Stage 06: Final Grid Code Modification Report

GC0101: EU Connection Codes GB Implementation – Mod 2

This proposal seeks to modify the Grid Code to comply with the obligations in the EU Connection Codes:

Published on: 20 February 2018

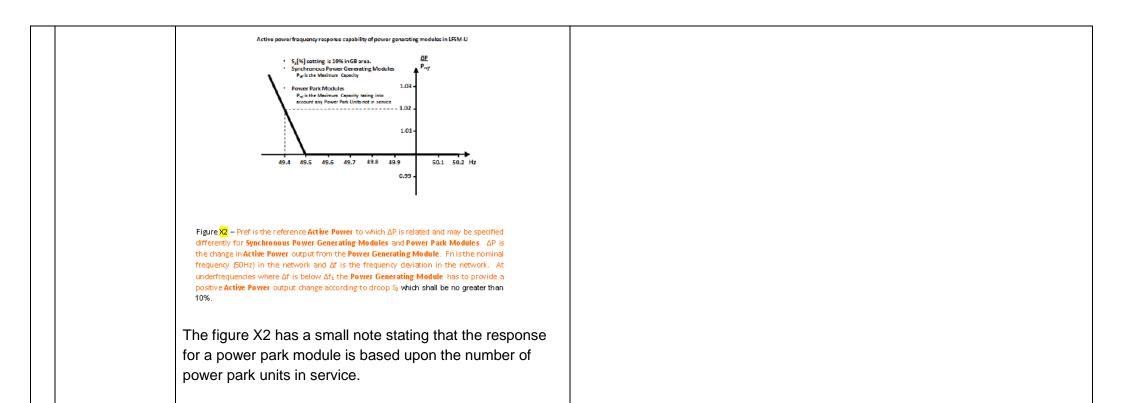
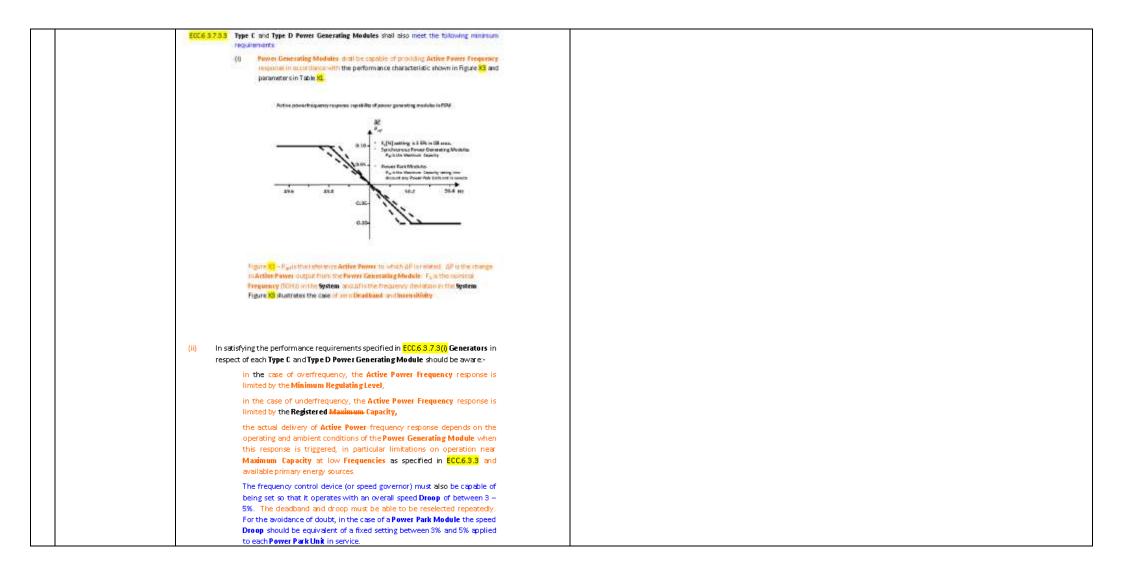
Response to comment on ECC6.3.7.3.3. (vii),
			Current GB Grid Code does not define this.

The figure X3 has a small note stating that the response for a power park module is based upon the number of power park units in service.

Windfarm manufacturers believed the windfarm operators and OEM's had the freedom to choose central or power park unit based frequency response (ECC6.3.7.3.1)
